# City of Beaumont

## Wastewater Treatment Plant Salt Mitigation Upgrade Project

### Change Order No. 21

September 08, 2021

SHEET  
**C-26**

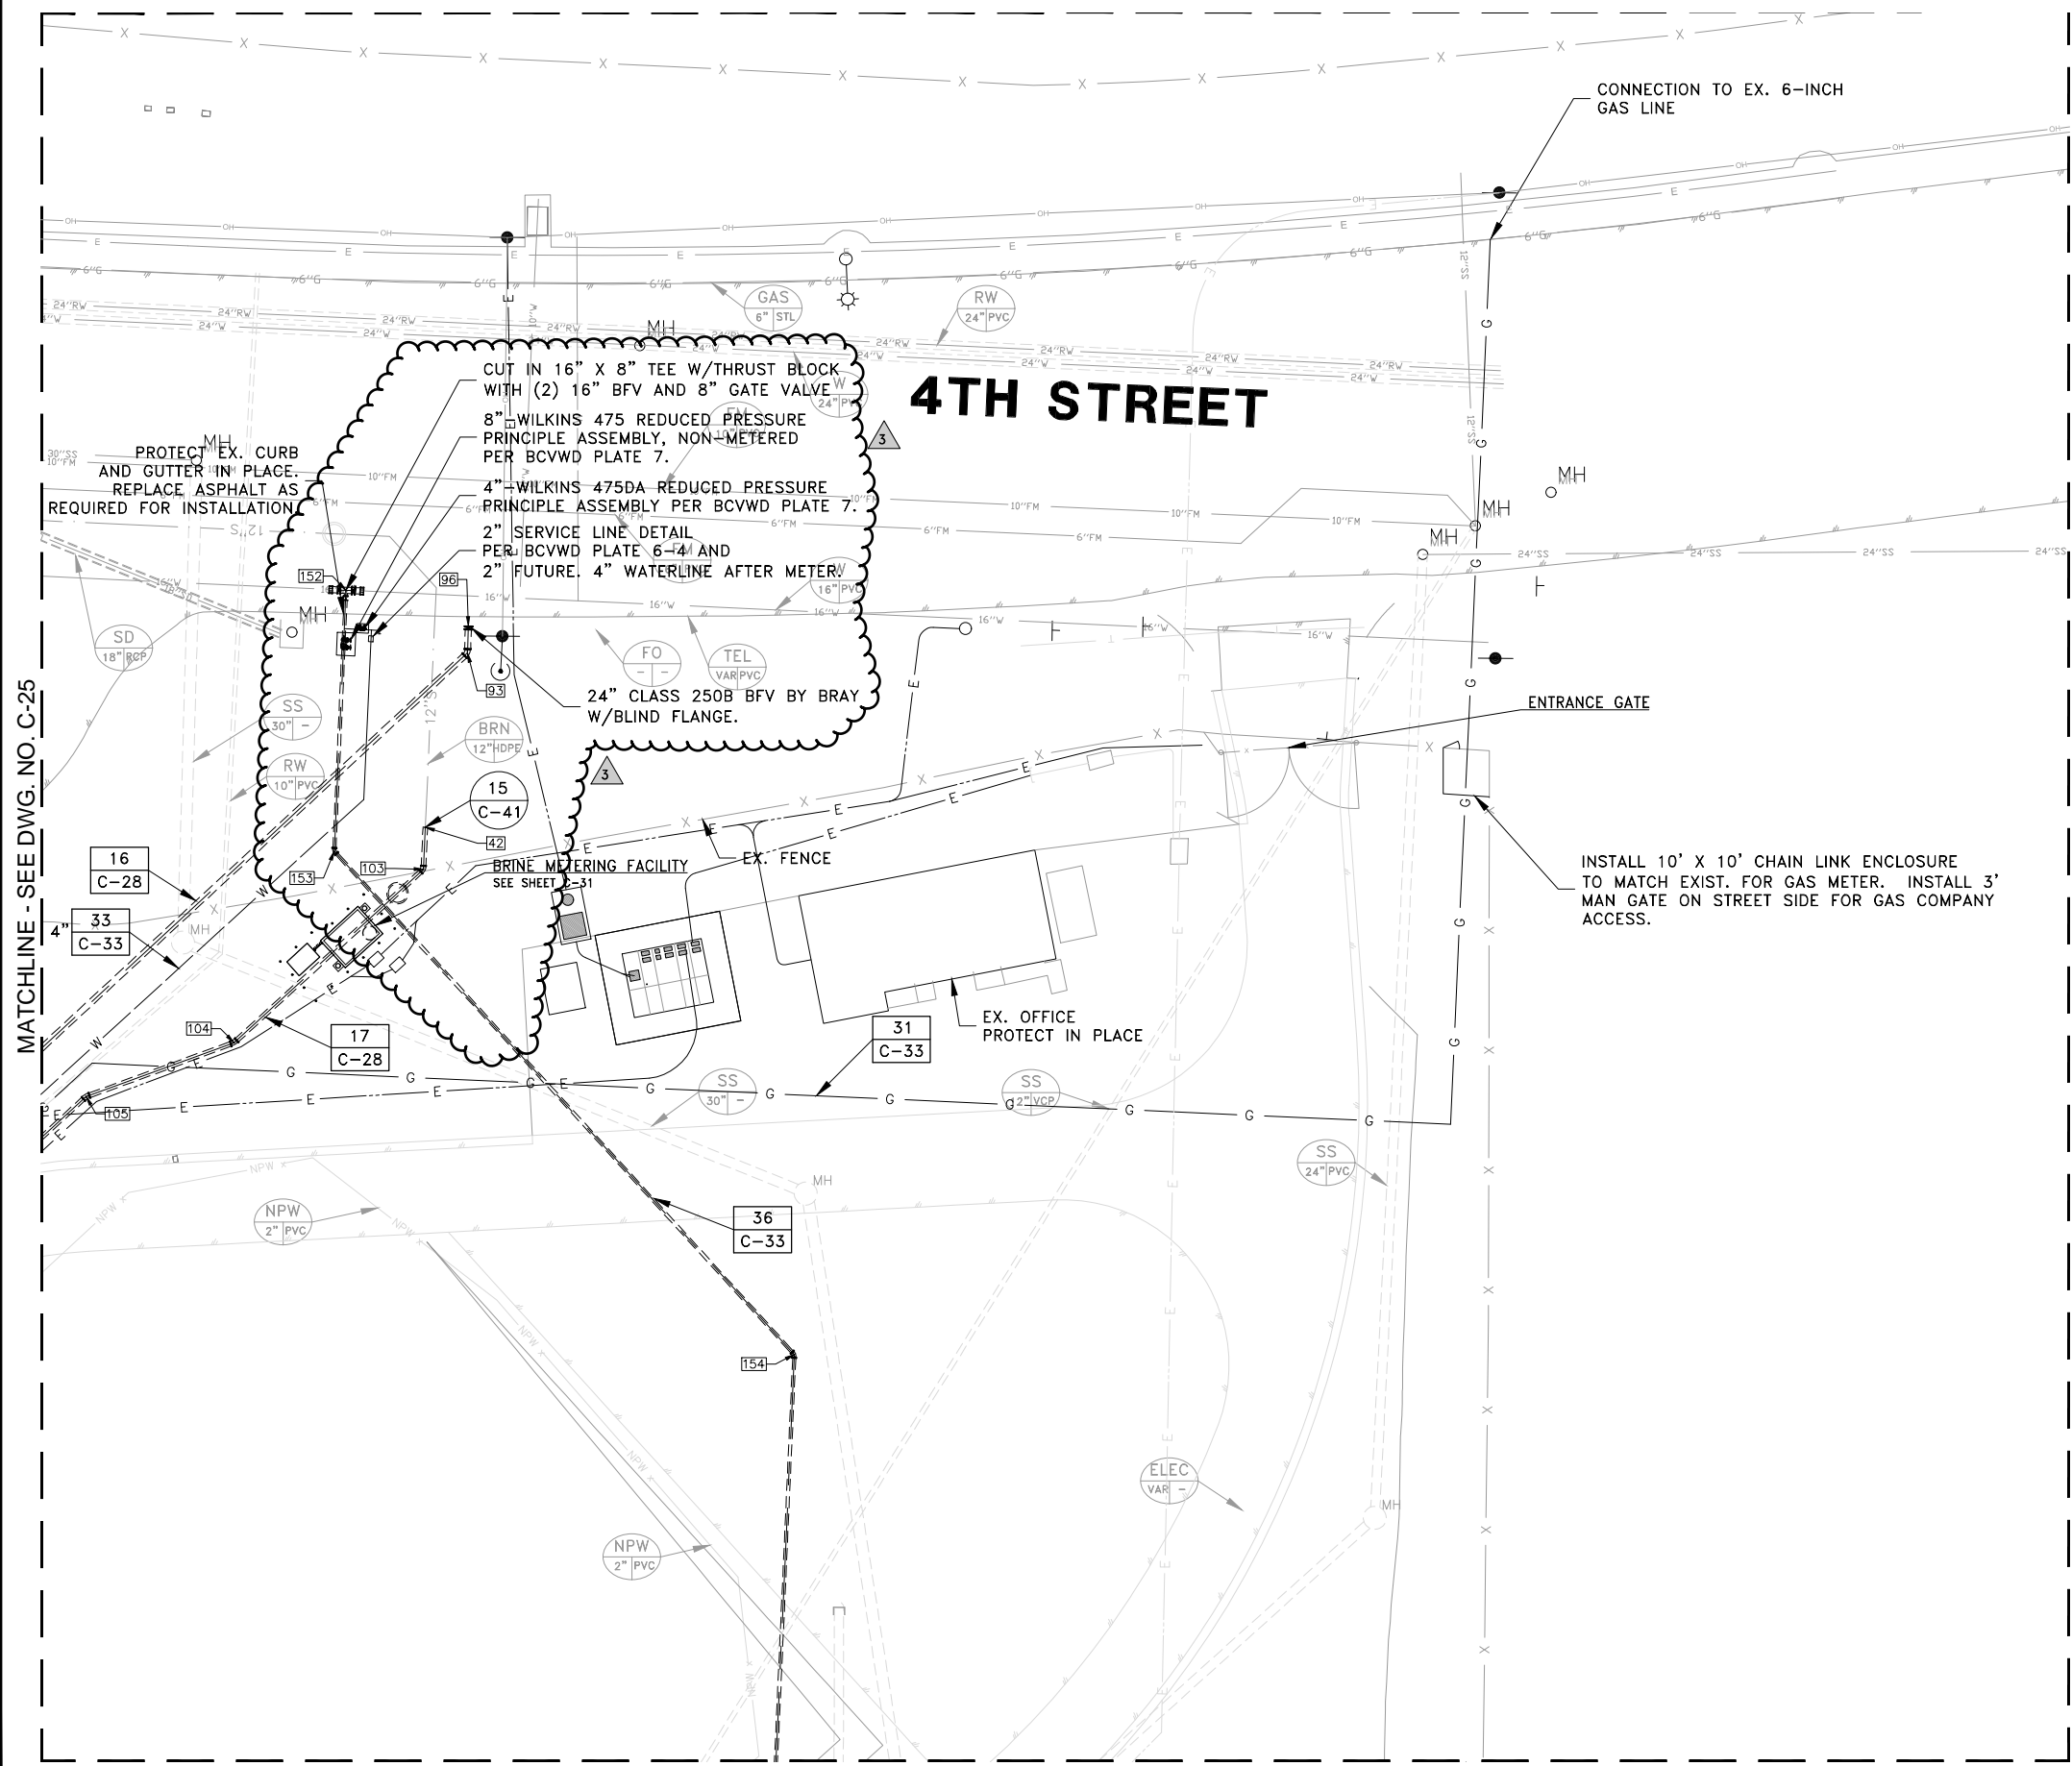
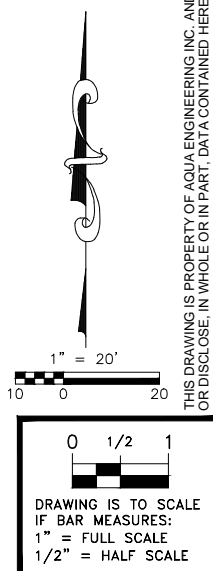
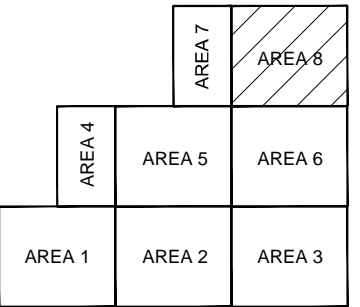
| <b>Note the following:</b><br>The BCVWD has requested changes to the connection points of the water line and recycled water line. These changes are shown on the attached drawing and are summarized as follows:   |                       |

CUT IN 16" X 8" TEE W/THRUST BLOCK WITH (2) 16" BFV AND 8" GATE VALVE  
 8" WILKINS 475 REDUCED PRESSURE PRINCIPLE ASSEMBLY, NON-METERED PER BCVWD PLATE 7.  
 4" WILKINS 475DA REDUCED PRESSURE PRINCIPLE ASSEMBLY PER BCVWD PLATE 7.  
 2" SERVICE LINE DETAIL PER BCVWD PLATE 6-4 AND 2" FUTURE 4" WATERLINE AFTER METER

SHEET  
**RWM-1**

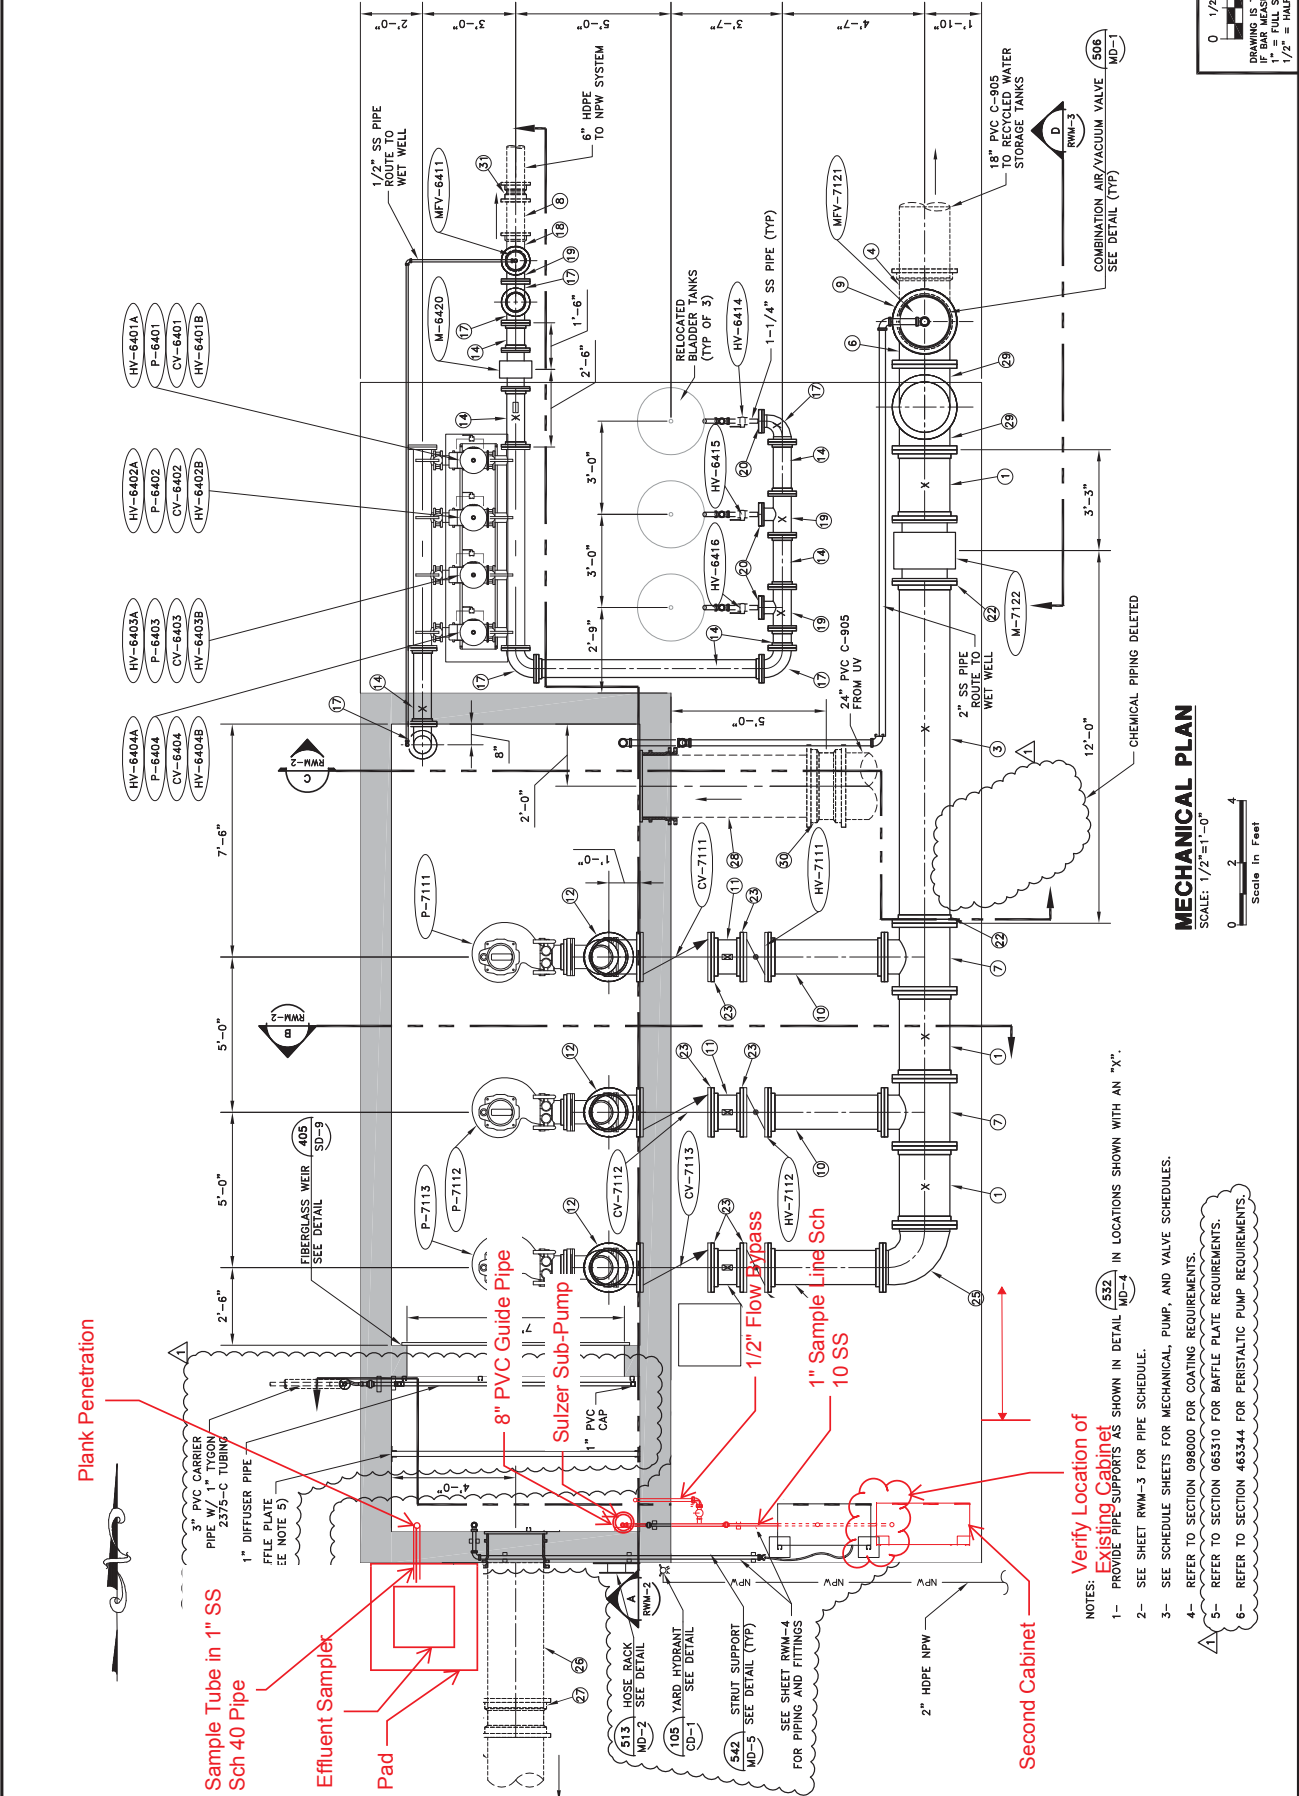
| <p><b>Note the following:</b></p> <p>The City desires to purchase new instrumentation and effluent sampler. The clarification outlines the required modifications to the Recycled Water Pump Station and provides a list of required instruments. This work also includes the removal and replacement of the sampling pump. Required electrical/controls work is described below:</p> <p>Power for the new submersible pump will be provided from LP-HW1 through conduits P7471 and P7471A, utilizing the same 2 #10 wires and #10 ground used to power the current metering pump. Conduit P7471A will need to be rerouted to access the new pump location. The submersible pump comes with a plug, so the subcontractor will either need to provide a dedicated outlet near the pump's location (as shown on RWM-1), or remove the plug and hardwire the pump into conduit P7471A (hardwire is preferred). The new sampler will also require power. The original documents on sheet LE-15 are showing the sampler being relocated and a new dedicated outlet for it. We assume this outlet is already installed and a conduit from it over to the new location should be installed and power it through that conduit.</p> <p>The fiber to copper media converter will need to be replaced by an unmanaged Ethernet switch with a fiber uplink, in order to connect to both the new SC4200 and the SC4200 previously installed. Power will also need to be extended to the new SC4200 transmitter and 4-20mA signals from the transmitter to RIO-HW will be sent via the two spare twisted shielded cables. Connect the two spare control wires to a spare discrete output in RIO-HW to control the effluent sampler.</p> |  |

CITY OF BEAUMONT  
SALT MITIGATION WWTP UPGRADE  
CIVIL  
OVERALL YARD PIPING PLAN

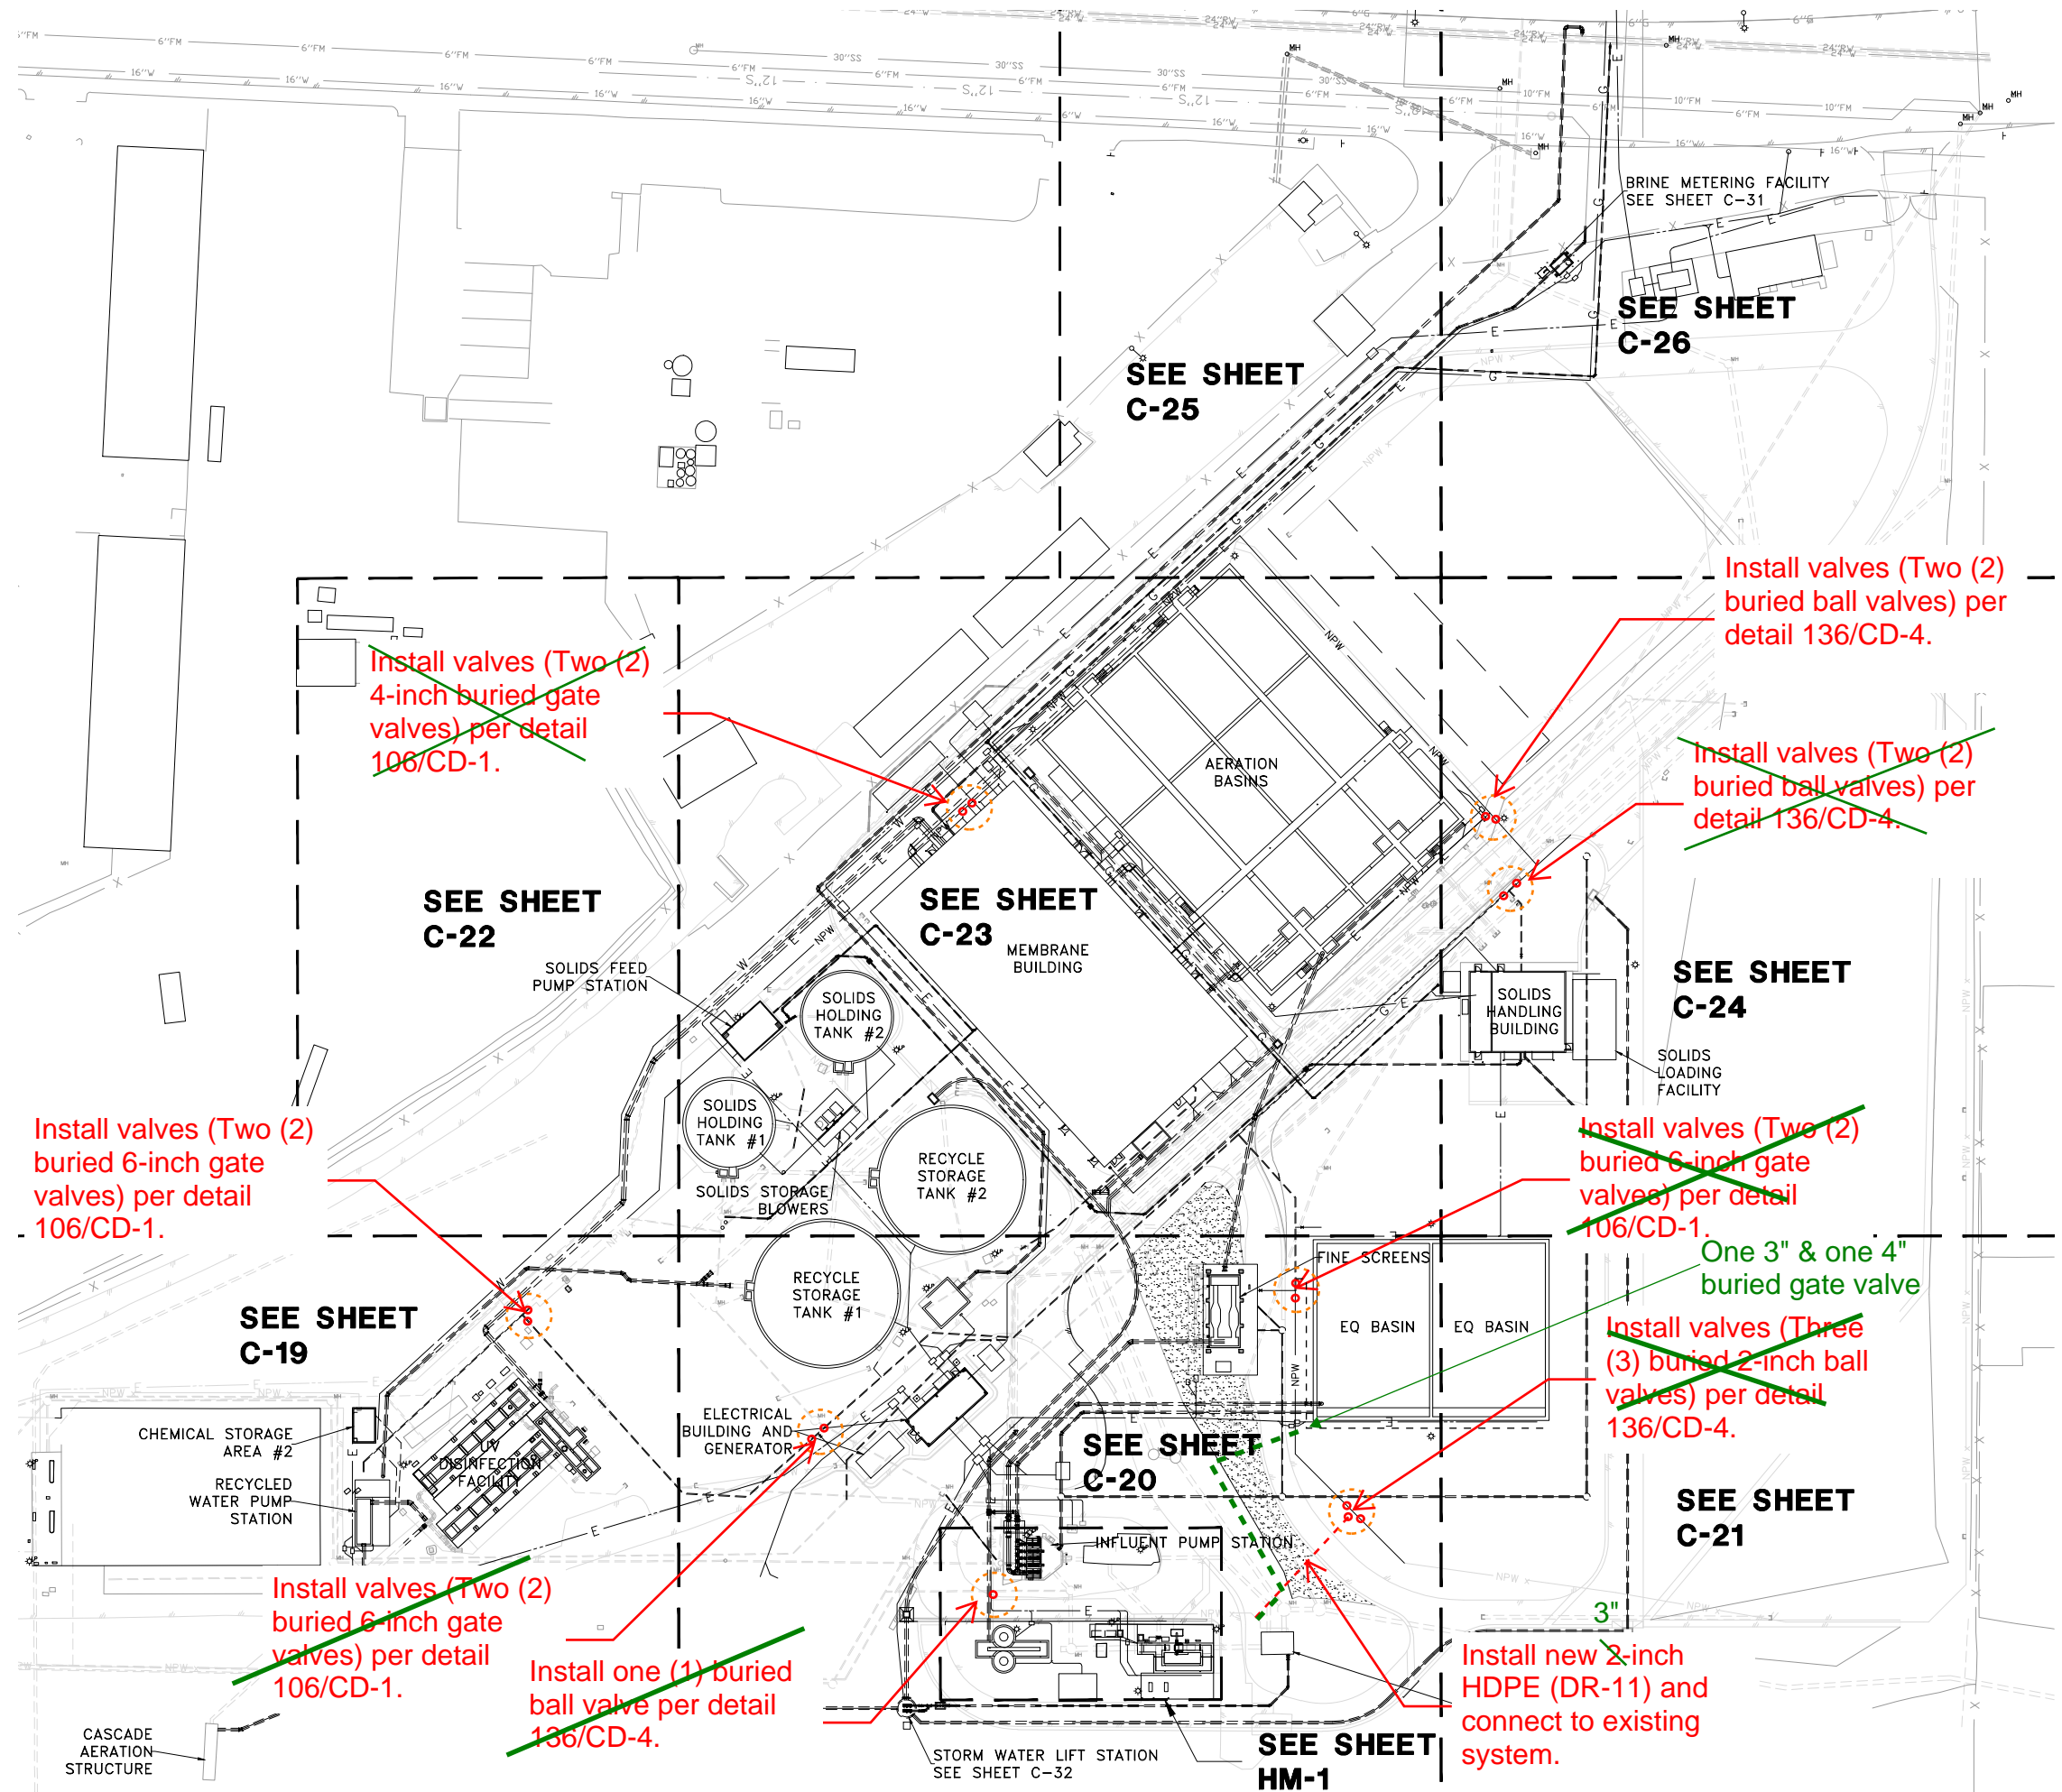
| <p><u>Reason for Design Changes:</u></p> <p>To increase the robustness of the NPW system addition of several valves is proposed as shown in the attached drawing C-18. Depending on the size of the piping, the type of valves installed will vary between buried gate and ball valves.</p> <p><u>Design and Scope Changes:</u></p> <p>These changes are shown on the attached drawing and are summarized as follows:</p> <ul style="list-style-type: none"> <li>• The onsite Fine Screens is a critical processing system requiring non-potable water for cleaning the screens. To further backup and maintain adequate flow to the Fine Screens system a non-potable water loop system shall be installed. This change request shall include the excavation and installation of a 3-inch HDPE non-potable water system by connection to the existing non-potable water at the Plant Headworks and route the new piping system to the southwest corner of the EQ basin.</li> <li>• In a previous change order, a new UV structure and equipment was approved for construction. Requested in this change request is the installation of non-potable water to the UV structure and hose bibb for general purpose washdown. The contractor shall excavate and install a 2-inch HDPE non-potable waterline from a connection point east of the non-Pot pump station and route to the northwest corner of the UV shade canopy.</li> <li>• The existing non-potable water piping system shall have gate and ball valves installed a various location shown on the modified drawing attached and as directed by City and MWH staff on site.</li> <li>• In a previous change order modification were made to the EQ basins with the addition of a discharge pumping station. Requested in this change request is the installation of non-potable water to the pump station and hose bibb for general purpose wash and priming the pumps. The contractor shall excavate and install a 2-inch HDPE non-potable waterline from a connection point on the non-Pot system east of the Fine Screen and route to the southwest corner of the EQ Pump Station.</li> </ul> <p><u>Cost Impact:</u></p> <p>MWH has reviewed the attached WML cost proposal and find it acceptable. Accordingly, MWHC recommends a contract cost increase of <b>\$17,500.62</b> to be executed in a change order for the modifications requested.</p> |  |
